SB203-21

Elite ETS Mid And Rear Steer Axle Hub Bolts. New Torque Value

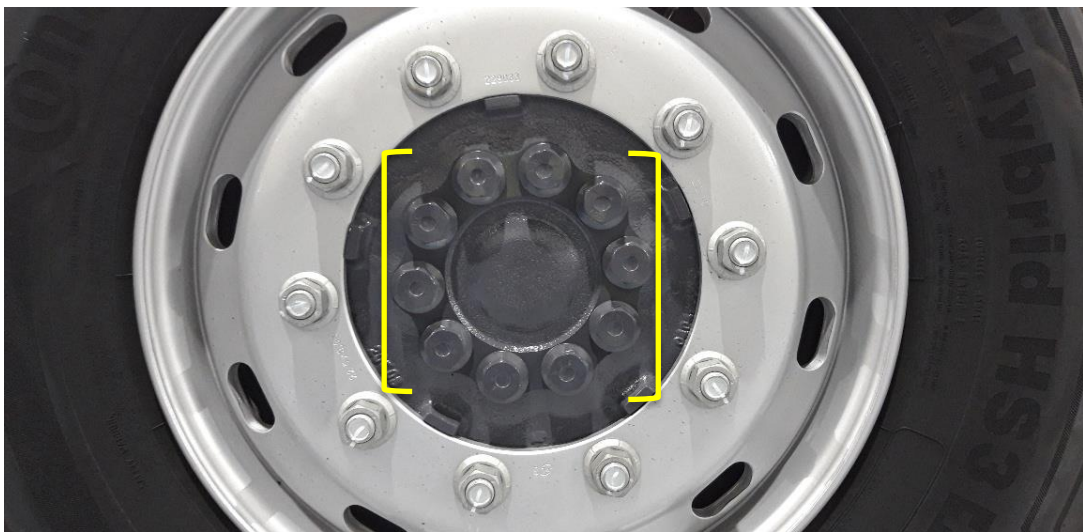
Following a review of their service literature, the supplier of the ETS mid and rear steer axle have changed their recommended torque value of the hub bolts (10 per side) from 180Nm plus 60° rotational angle to 500Nm.

Dennis Eagle recommend that on the vehicles next planned inspection, the hub bolts are physically torqued to the new value of 500Nm and the bolt security is then checked and maintained on the vehicles six weekly safety checks.
